AMENDMENT C CHANGES. SHOWN CLOUDED.

VIEW FROM FISHERMANS BEACH UPDATED WITH NE PROPOSAL.  
DRAWING REGISTER UPDATED.

41 & 43 BEACH ROAD COLLAROY  
LO1 1 DP300846 AND LOT 2 SEC 7 DP7391

COVER + PHOTOMONTAGES

DRAWING TITLE	SCALE:	DRAWING NO.
			ANALYSIS OF PROPOSAL AGAINST DCP B1 "WALL HEIGHT" CONTROL SOUTH EAST AREA DETAIL			1:100 at A1 & 1:200 at A3	DA 106

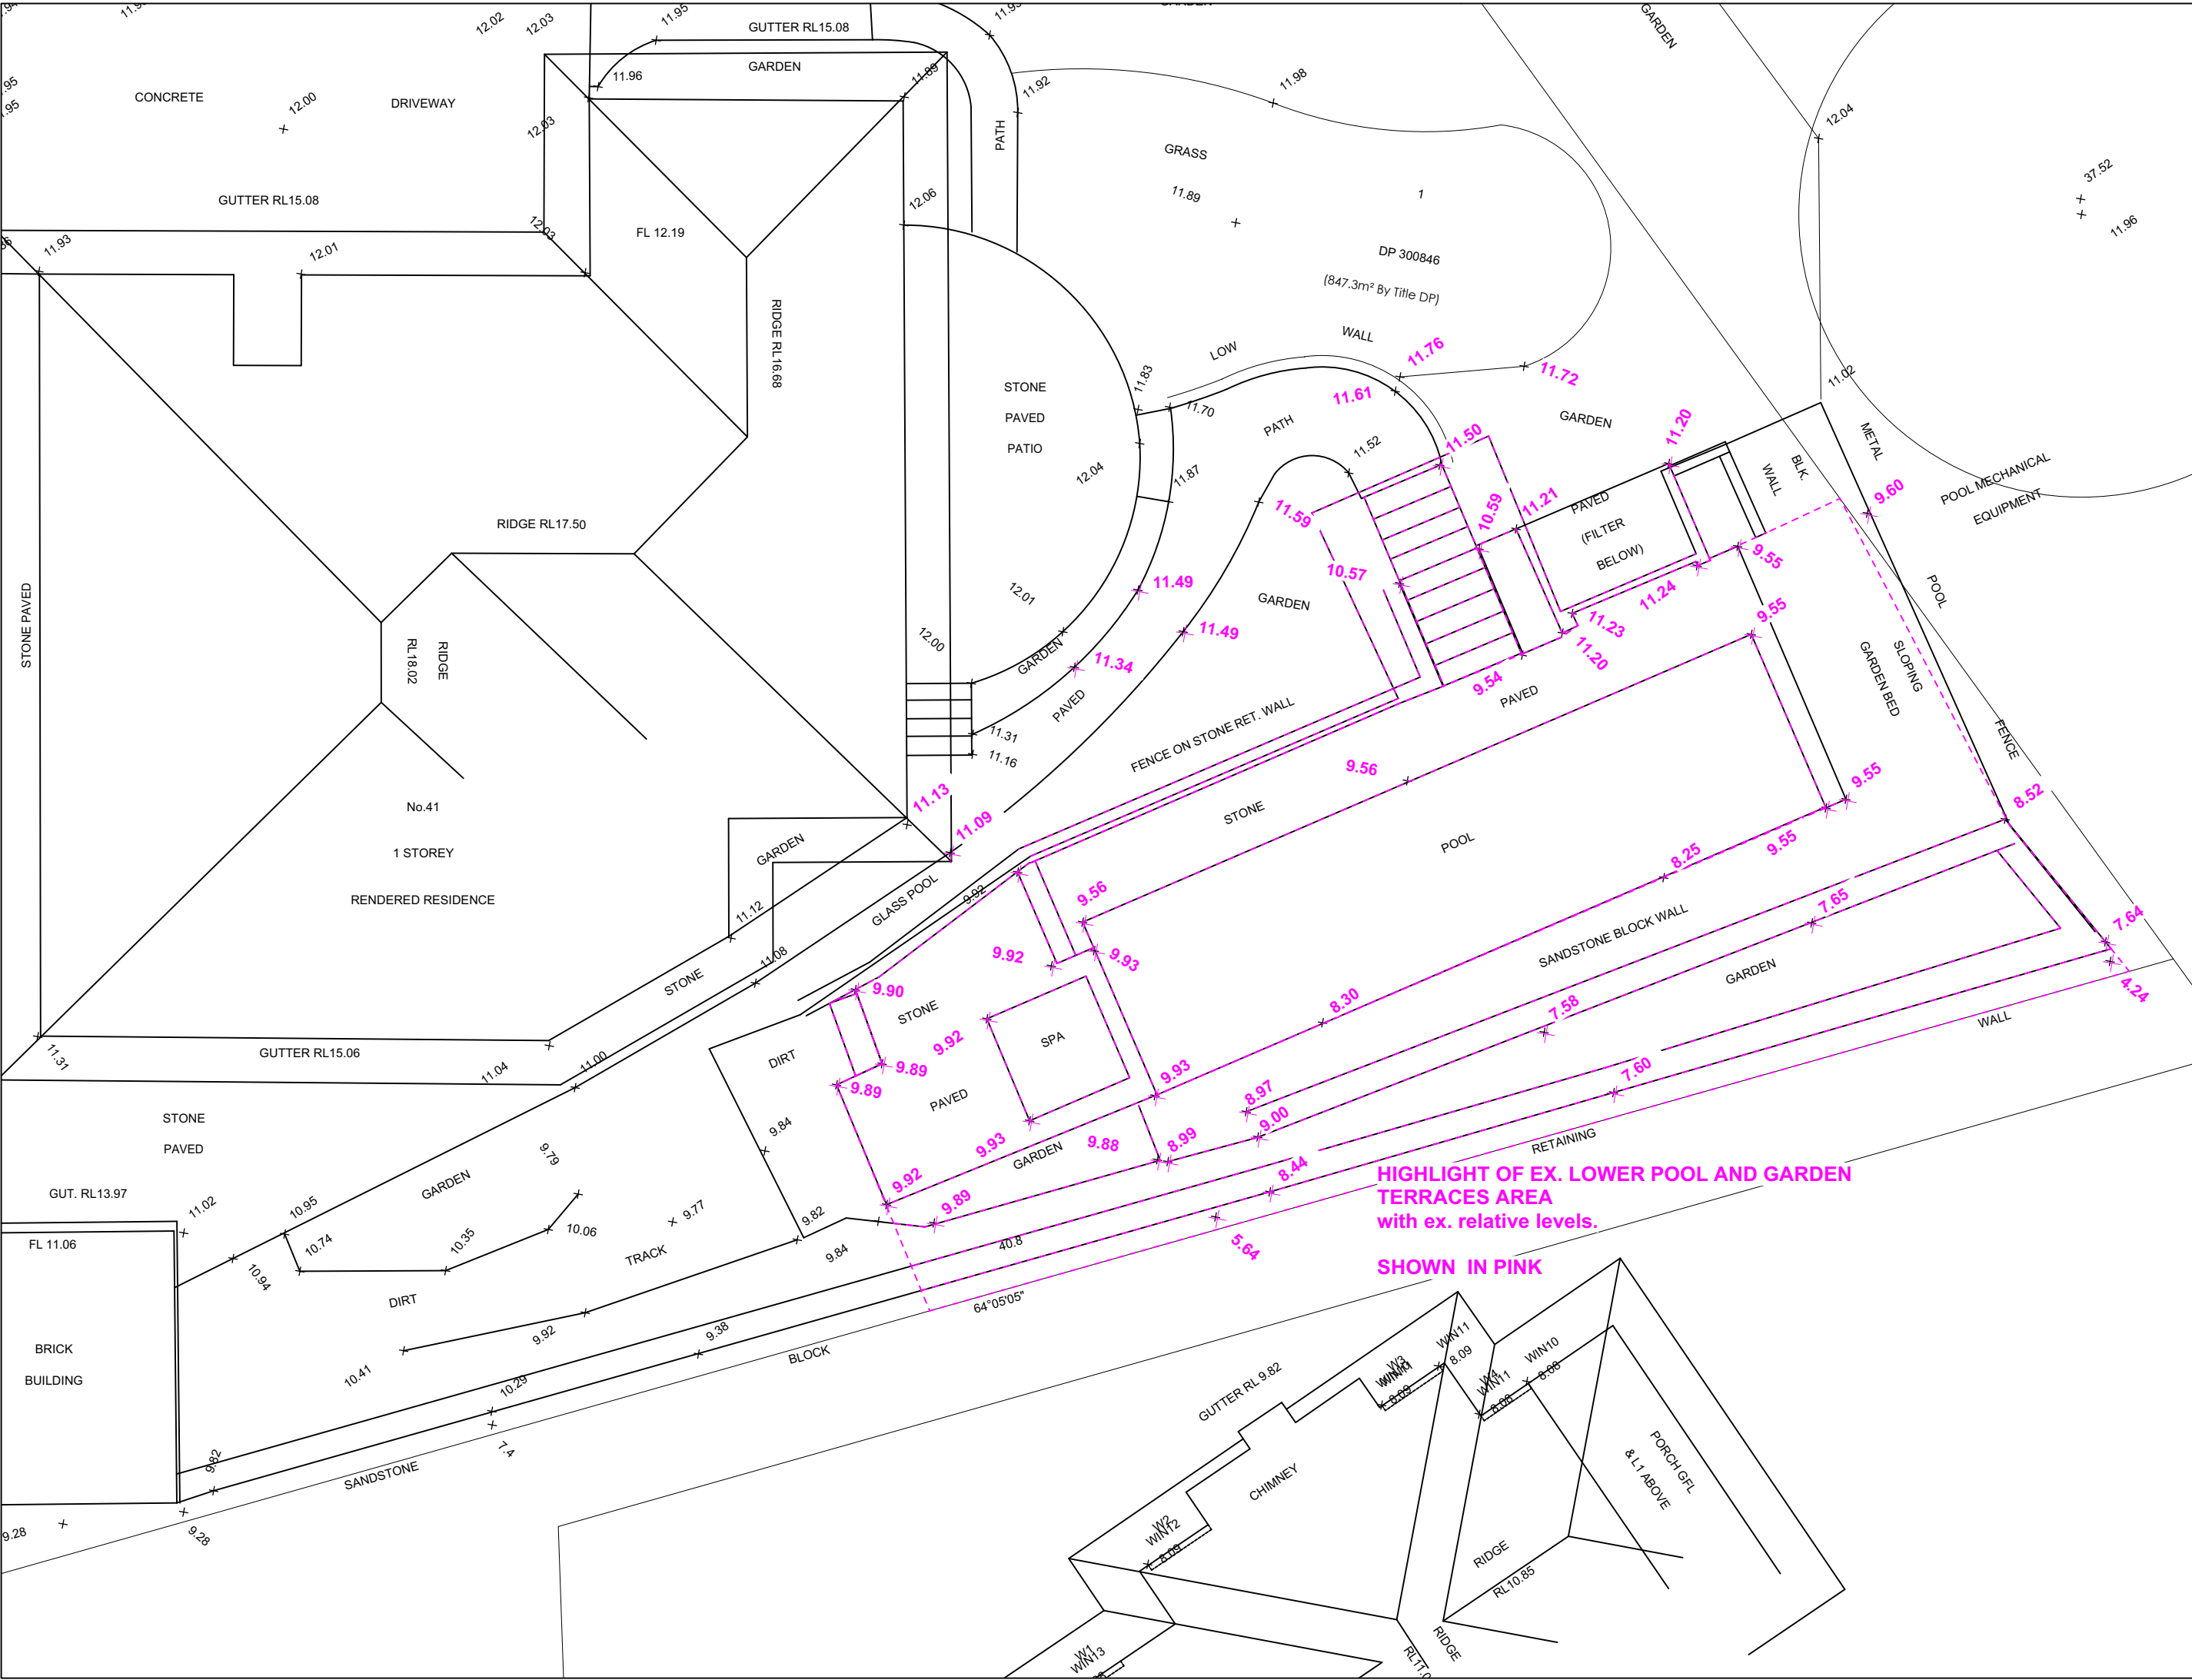
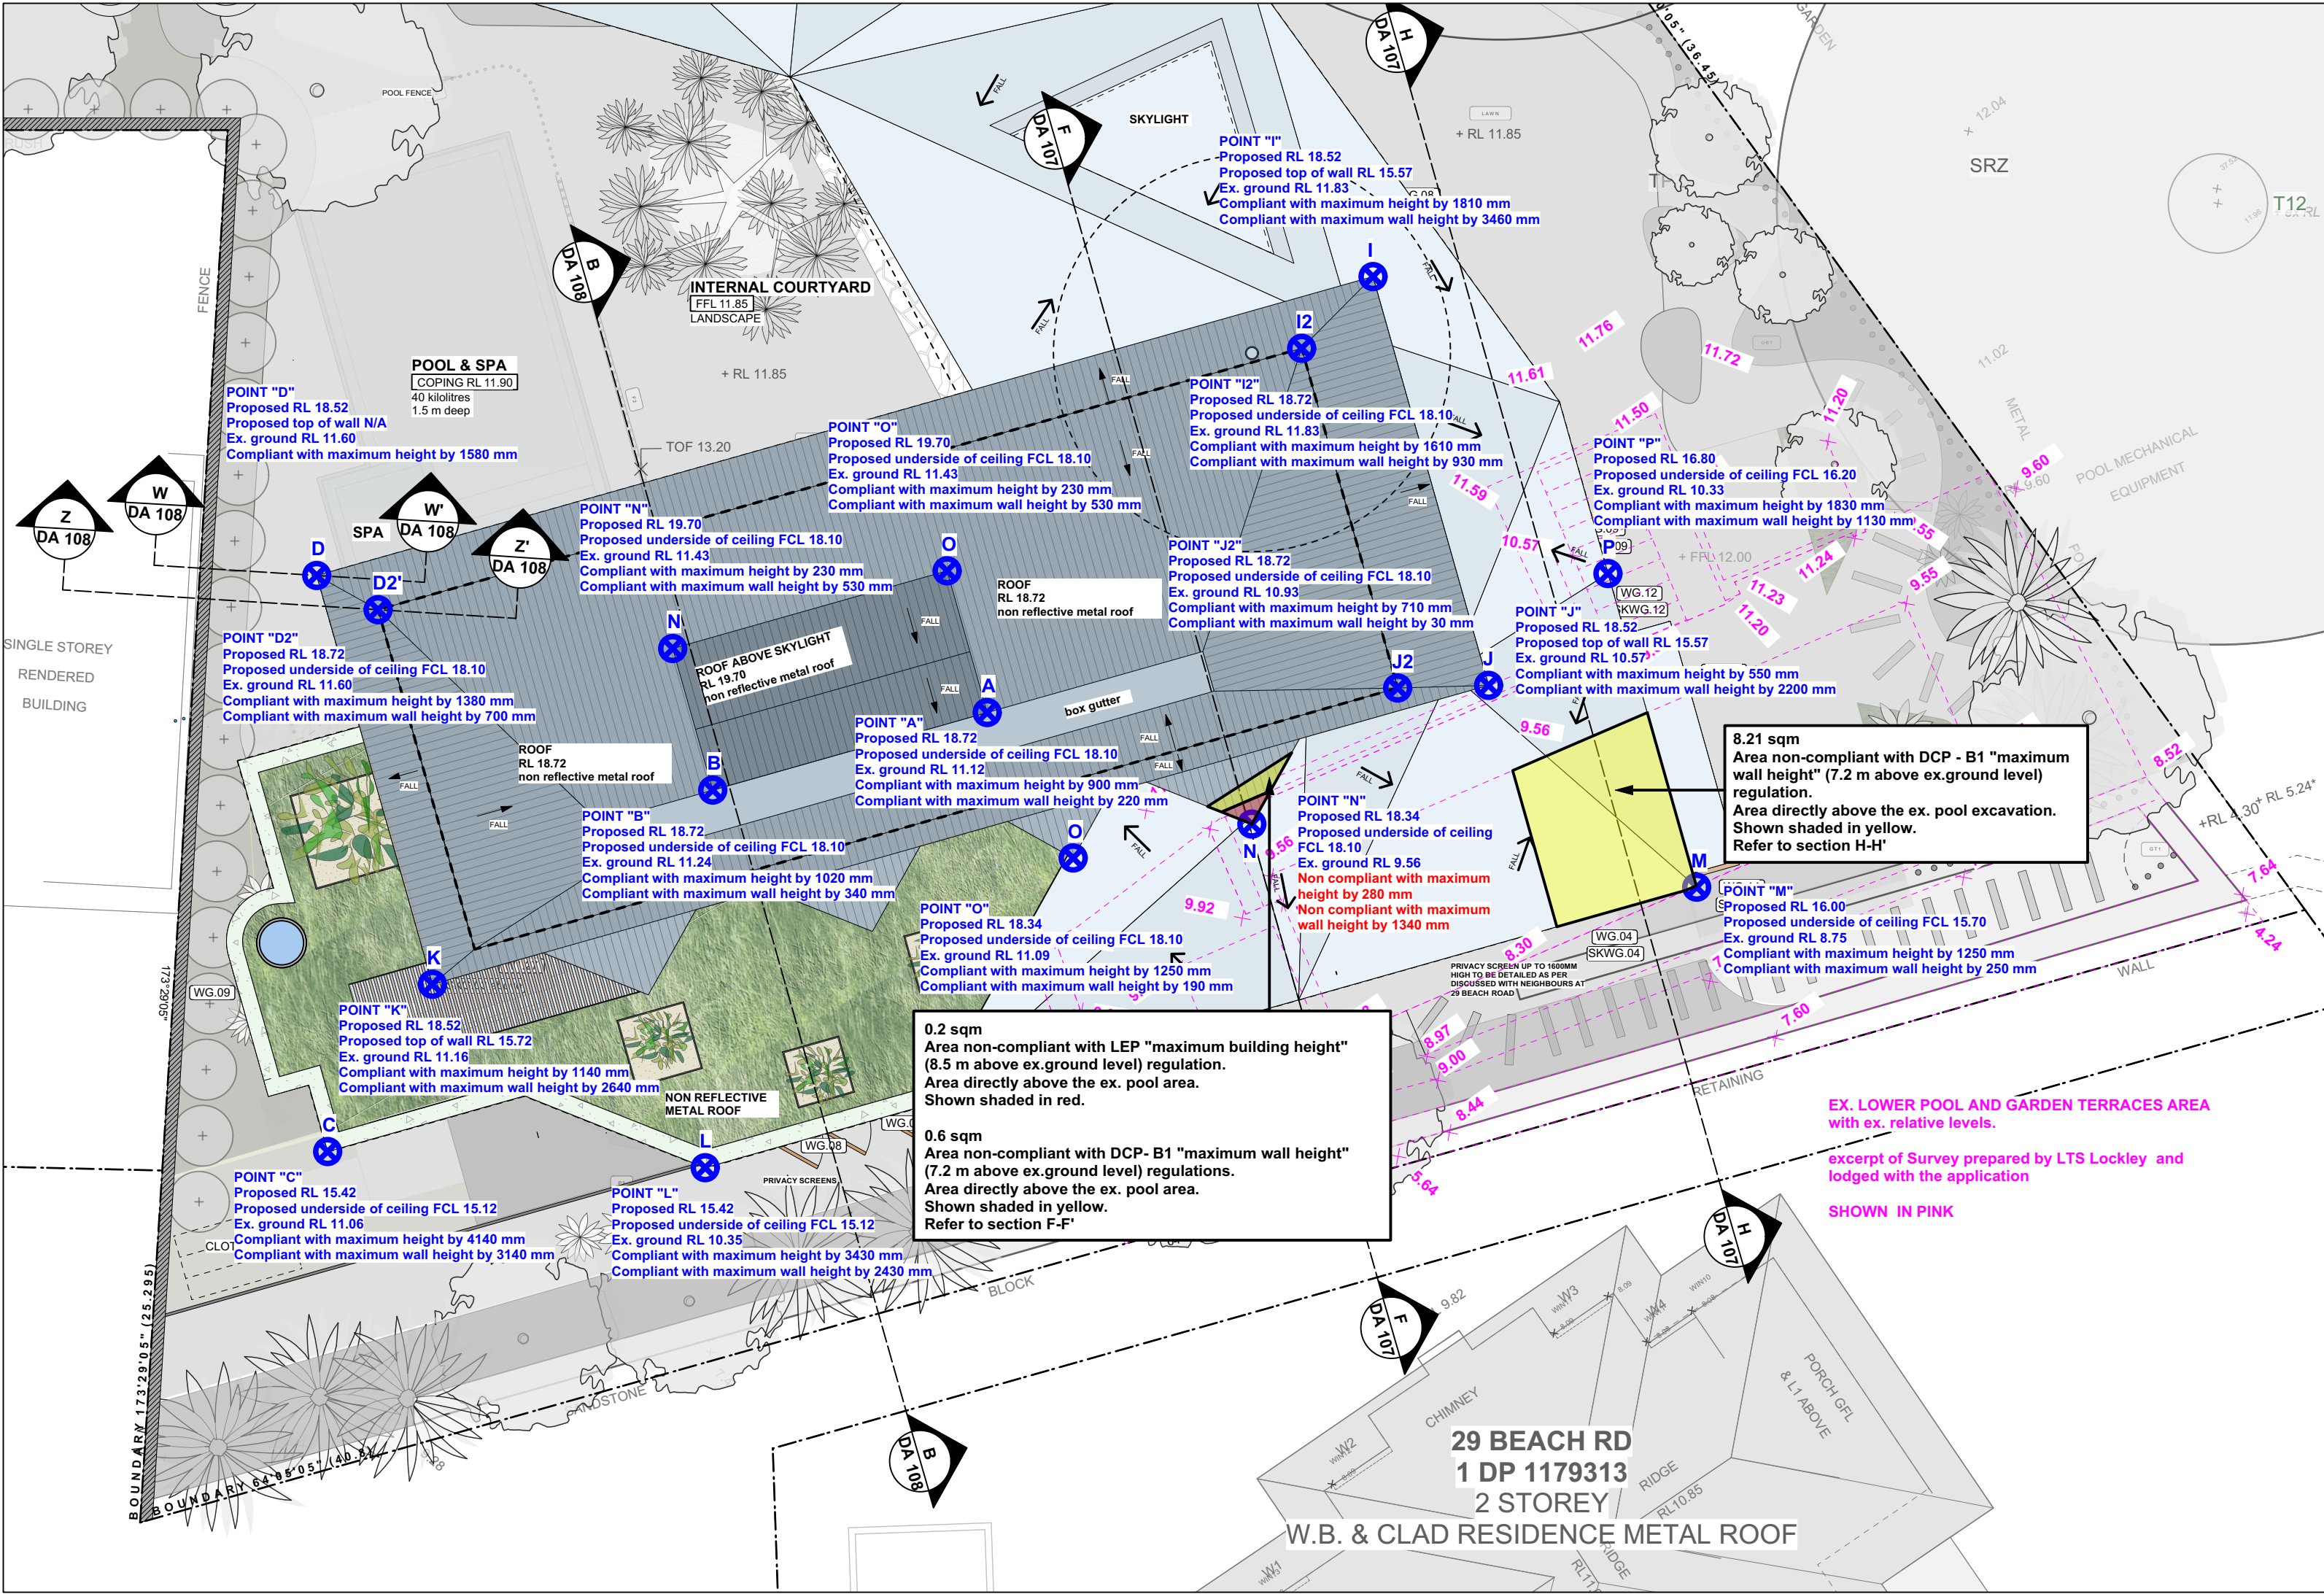
8.21 sqm  
Area non-compliant with DCP - B1 "maximum wall height" (7.2 m above ex.ground level) regulation.  
Height above 7.2 m control = 0.4 m at the highest point. 0.2 m as average.  
Area directly above the ex. pool excavation.  
Shown shaded in yellow.  
Refer to section H-H'

0.6 sqm  
Area non-compliant with DCP- B1 "maximum wall height" (7.2 m above ex.ground level) regulation.  
Height above 7.2 m control = 0.3 m in 0.4 sqm out of the total 0.6 sqm and 1.3 m in 0.2 sqm out of the total 0.6 sqm.  
Area directly above the ex. pool area.  
Shown shaded in yellow.  
Refer to section F-F'
